**NUMBER:** 18-087-16 REV. A

Engine Oil Viscosity Upgrade And Flash Enhancements

| 2016   | (WK) | Jeep Grand Cherokee |
| **2016 | (DS) | Ram 1500 Pickup**   |

***Fig. 1 Cap Before Sticker Applied***

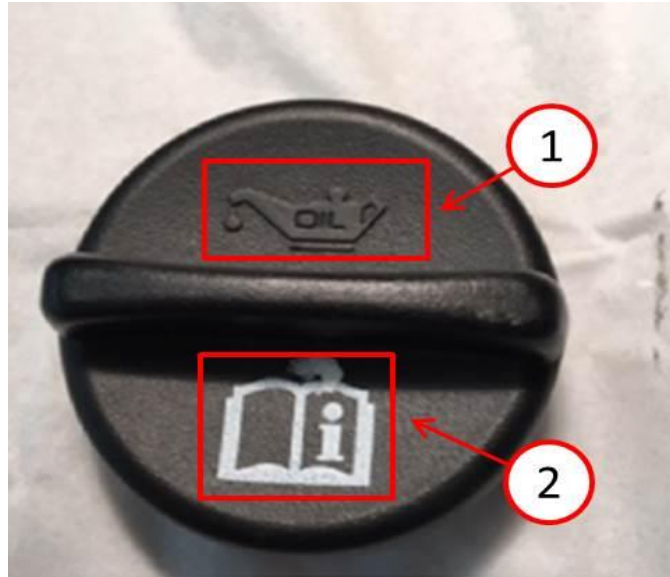
6. Remove oil fill cap.
7. Clean top of oil fill cap with Isopropyl alcohol or equivalent and apply engine oil viscosity rating sticker as shown in (Fig. 1).

- 1 - Do Not Cover This Embossed International Oil Symbol
  - 2 - Cover This Old Oil Info Symbol With The New "5W40" Label
-
